Mobile Intel® Pentium® 4 Processor - M

Specification Update

May 2004

Revision 023

Figure 13. System Bus Reset and Configuration Timings

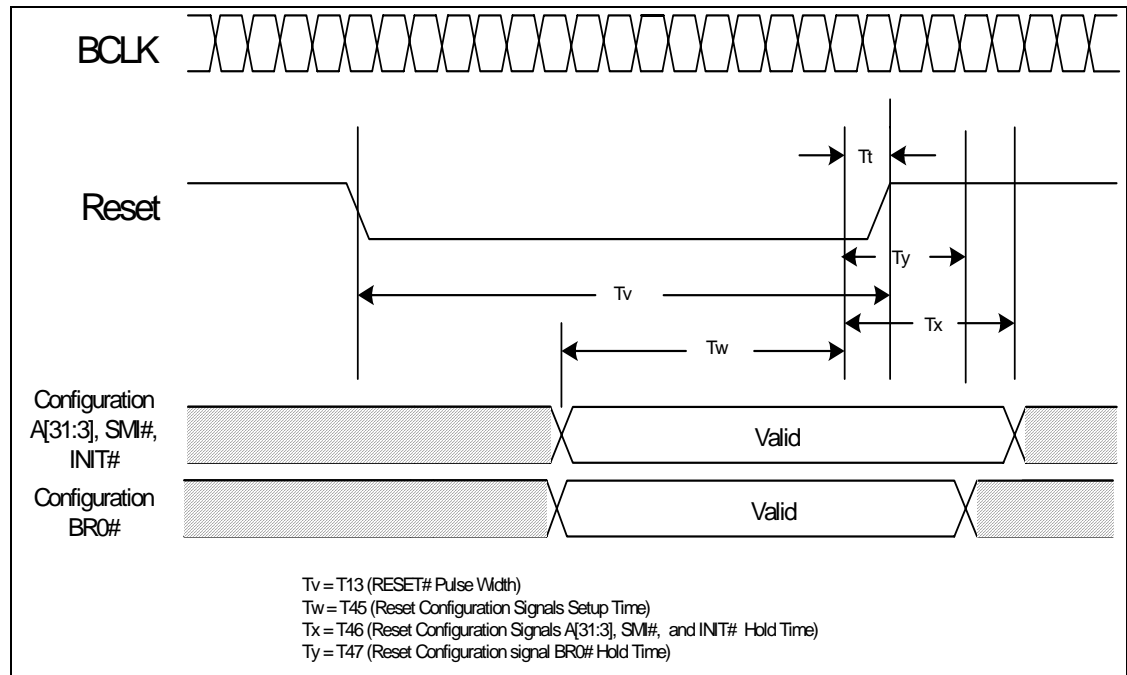
T2. BR0# Maximum Hold Time Specification Change

The BR0# maximum hold time has changed to 2 BCLKs. This change will be shown in the “System Bus AC Specifications (Reset Conditions)” table and “System Bus Reset and Configuration Timings” figure of the *Mobile Intel® Pentium® 4 Processor - M Datasheet*. This change will be incorporated in the next revision of the datasheet.

The following figure will be modified to reflect this change:

T# Parameter	Min	Max	Unit	Figure	Notes
T45: Reset Configuration Signals (A[31:3]#, BR0# INIT#, SMI#) Setup Time	4		BCLKs	13	1
T46: Reset Configuration Signals (A[31:3]#, INIT#, SMI#) Hold Time	2	20	BCLKs	13	2
T47: Reset Configuration Signal BR0# Hold Time	2	2	BCLKs	13	2
